GUAM MEMORIAL HOSPITAL AUTHORITY

AMENDMENT #4

GMHA Invitation for Bid No. 005-2025

New Security Access Control System (ACS) Replacement Project and Preventative Maintenance Services

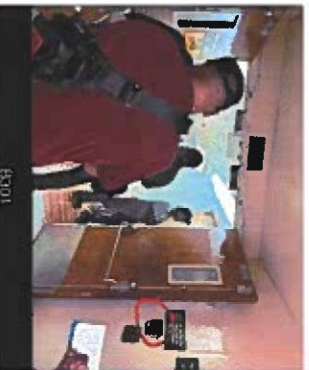
7. For the intercom. We located the door stations, question is do they all call one master station? Or do they call a specific department's master station? If each door intercom calls different master station/ departments, please send a list. We'll need a quantity of master stations, physical location, and which door intercom will report to it.

Example: Does this intercom call someone inside Med/Tele or one main master station elsewhere?

Response: All specific Intercom calls a specific department's master station at the department's Nurse Station (not one master station for ALL). Example: The Intercom at Med-Tele main entry door calls to Med-Tele Nurse Station only. The IFB is hereby amended to include six (6) additional ACS Intercom Kits and Panels.
